Lane Cove Council

Doc Ref: 76556/18

Re: Response to Crows Nest Rezoning Proposal

Figure 2 – Proposed building heights and uses

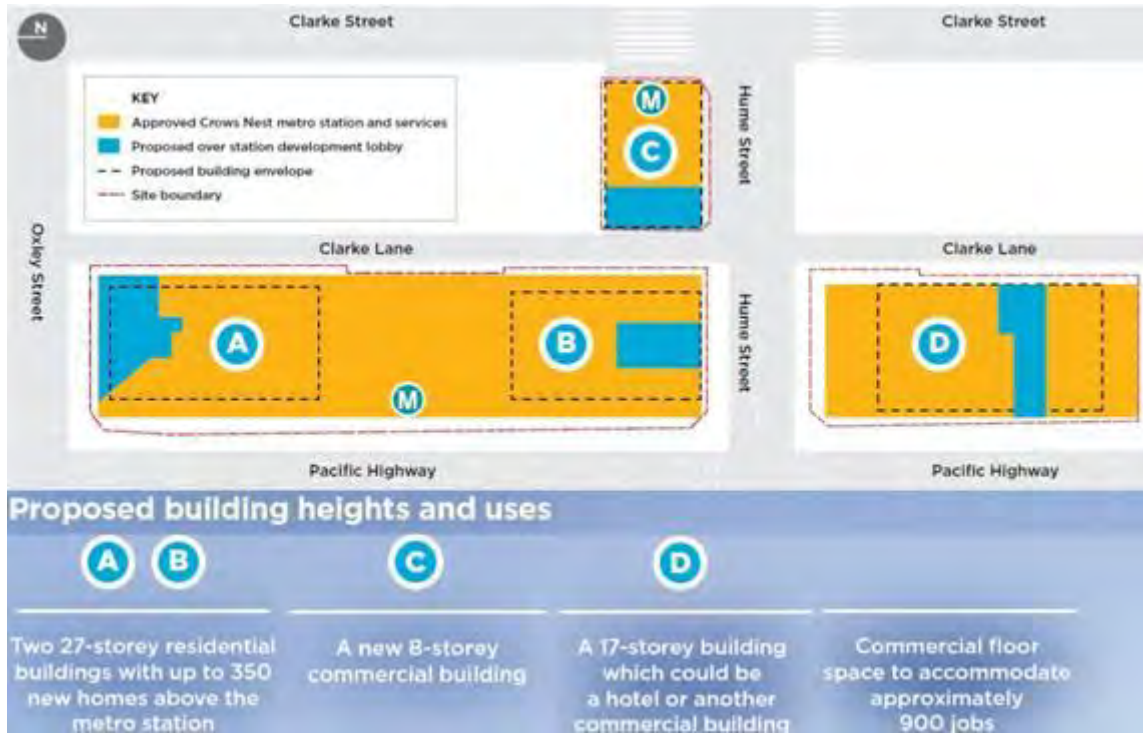
In addition to the community facilities, mentioned above, further consideration should be given to alternative and/or additional commercial floor space on the Metro site; i.e. the proposed hotel could be re-located to Building C and commercial offices to Building B. No clear justification for a hotel has been provided as part of the rezoning proposal.

Figure 4 – Indicative Massing Diagram

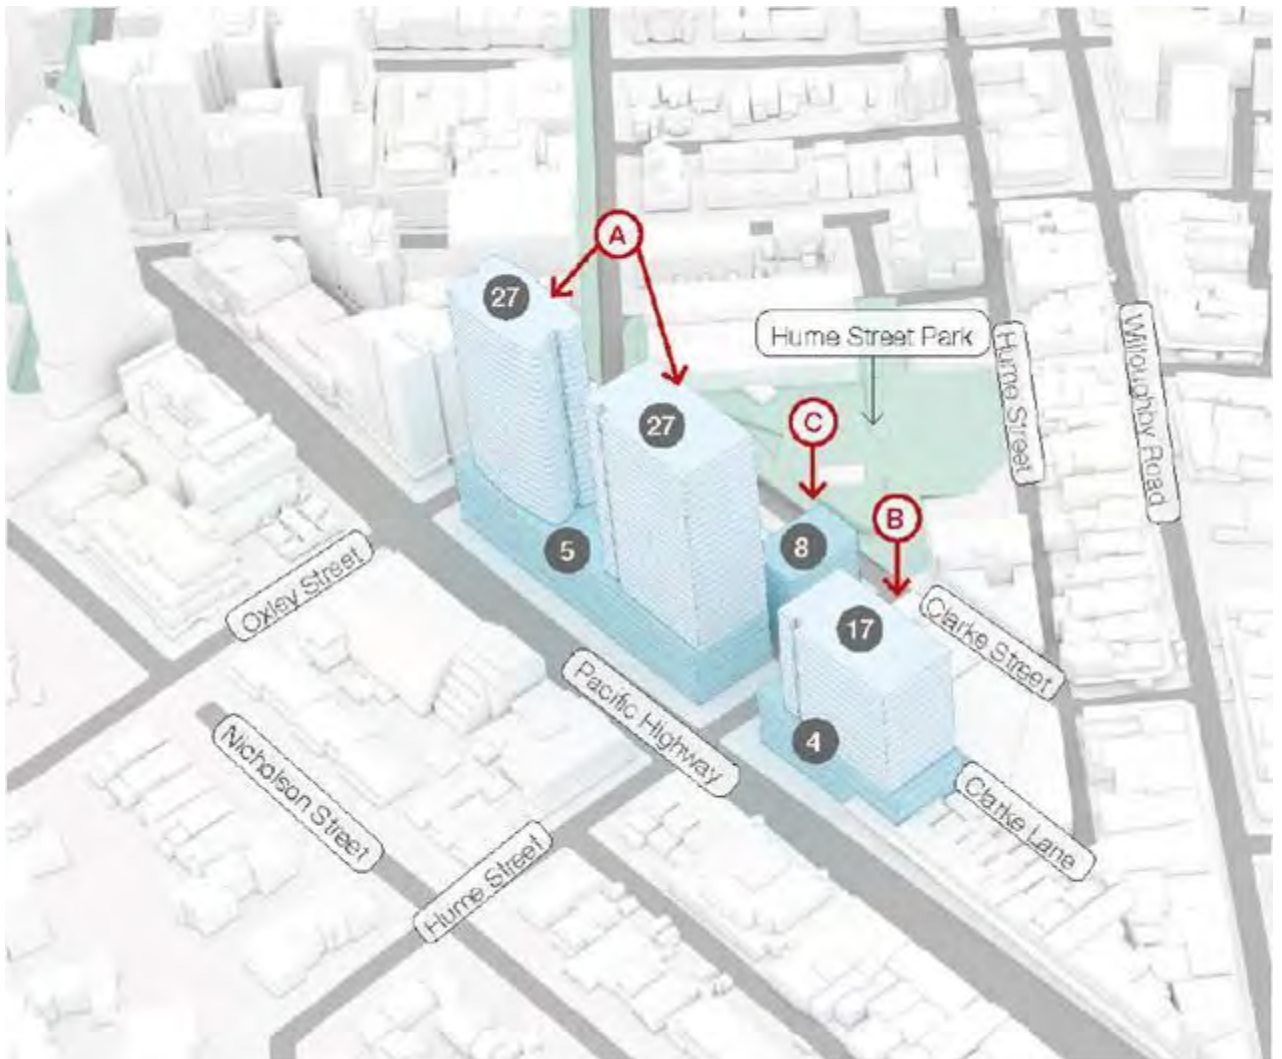
The scale proposed provides minimal transitions to the surrounding areas, but rather extends the height from the St Leonards Commercial centre into the Crows Nest Village precinct, previously stopped at Oxley Street, which the current imagery demonstrates building envelopes, which do not resolve the transition.

It will therefore be important that the Design Excellence Clause clearly states the principles adopted to be used to ensure the best planning outcome and places greater emphases on resolving the transition issue.

Errors in figures from – Crows Nest Sydney Metro Sites: Detailed Urban Design Study

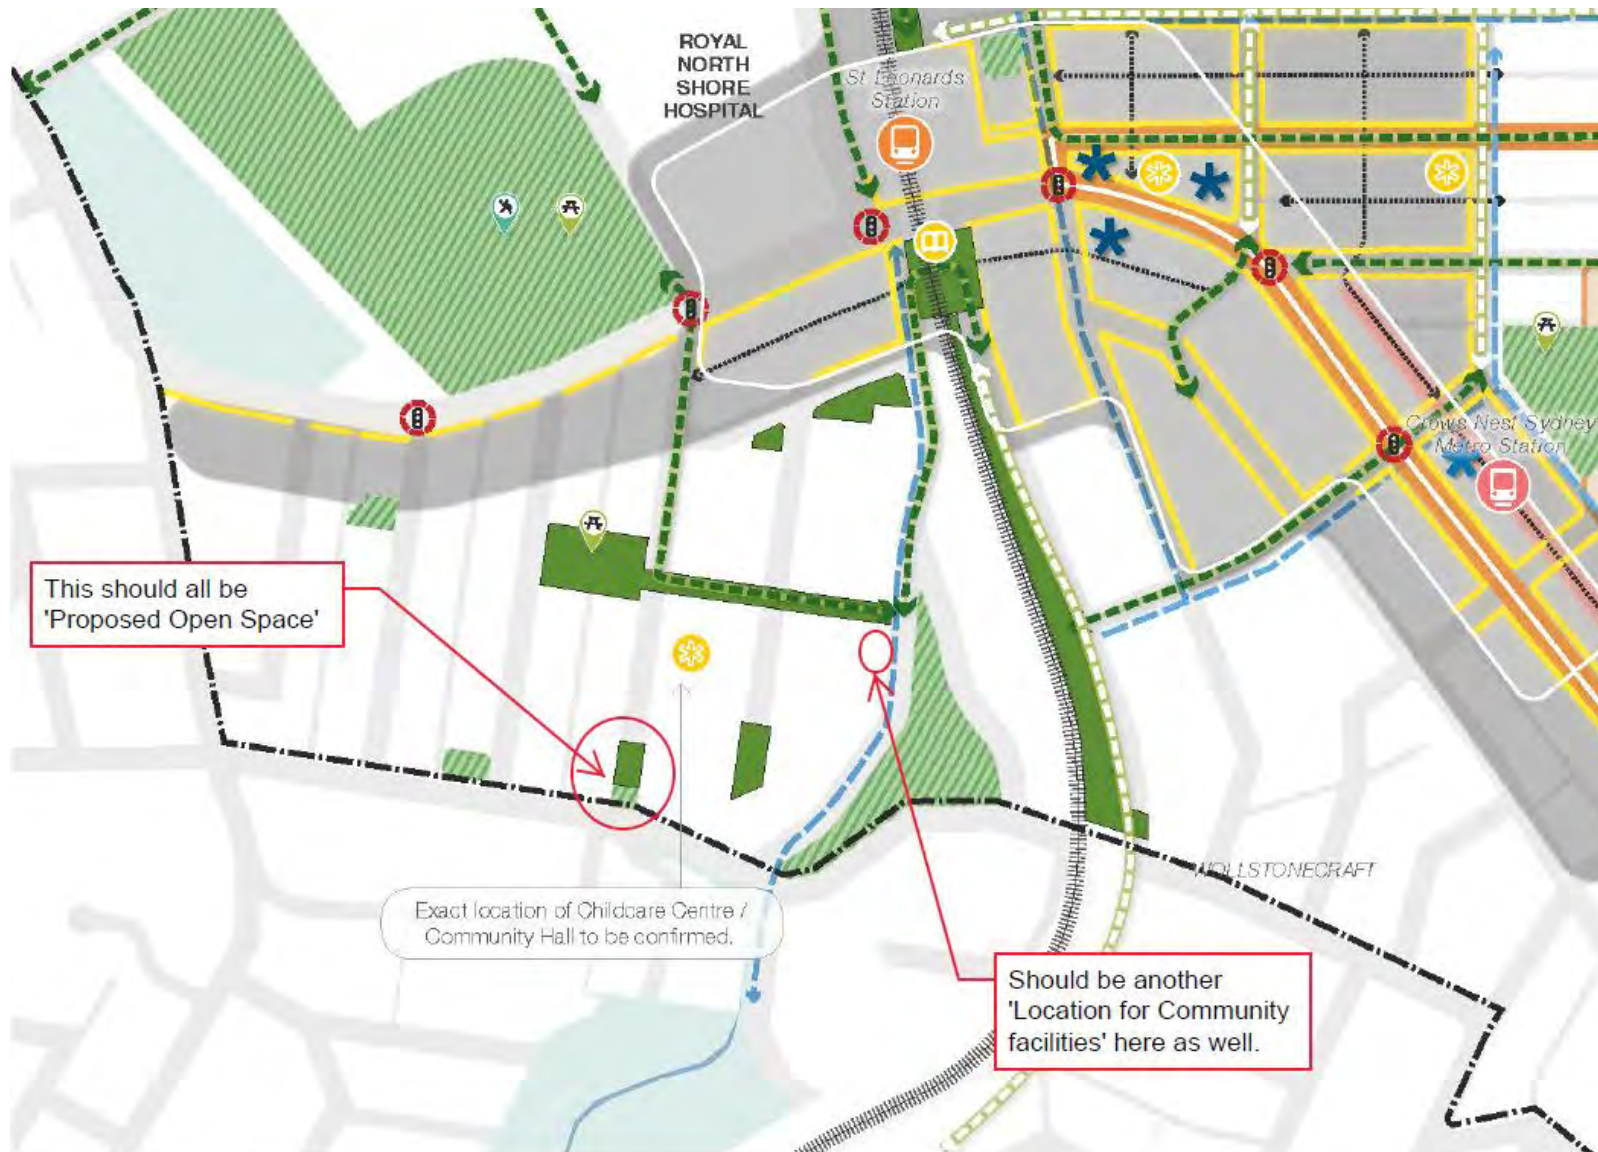
Council has noticed minor errors in the document '*Crows Nest Sydney Metro Sites: Detailed Urban Design Study*'. Both figures on pages 23 and 24 of this report provide incorrect information and are required to be updated. These errors are explained in **AT-1**.

Draft Crows Nest Metro Rezoning Proposal:
Errors
